Access Compliance Report Public Rights-of-Way (Curb Ramps)

Main Street: MILNEBURG_ST Cross Street: BIENVILLE_AVE Location: NE

ADA ID: RPRK210923181406 Ramp Type: Type 1 - Perpendicular Diagonal Initial Pass/Fail: Pass Overall Compliance: No Severity Score: 5

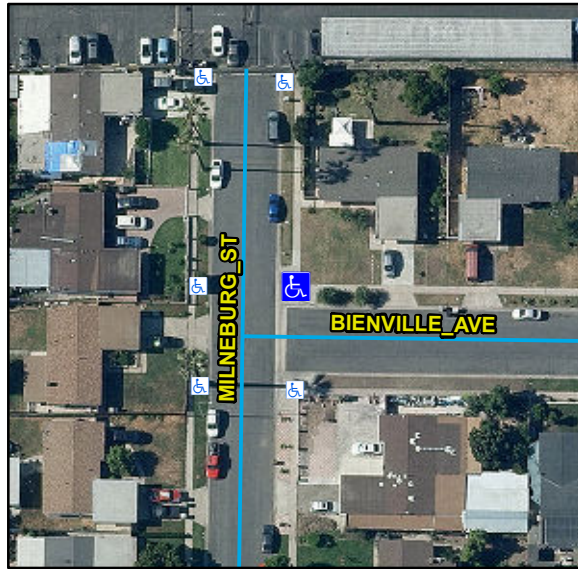
R304.5.4, STD 1115

N/A	Ramp Inside Crosswalk 1	N/A	Yes	Ramp Inside Crosswalk 2	N/A
	Crossing 1 Slope (%)	7.8		Crossing 2 Slope (%)	3.4
	Crossing 1 Cross Slope (%)	1.1		Crossing 2 Cross Slope (%)	0.7
Yes	Gutter Ponding	No	Yes	Curb Slope	4.1
Yes	Gutter Lip Height (in)	0		Road Run Slope (%)	1
No	Gutter Run Slope (%)	6.9		Road Cross Slope (%)	4
Yes	Gutter Cross Slope (%)	1			
Yes	Overall Surface Condition: Acceptable		Yes	Perp Joint Present	Yes
	Cross Gutter Present?	Yes		Spandrel Present?	Yes
	Replace Cross Gutter?	No		Replace Spandrel?	No

Remove & Replace Gutter.
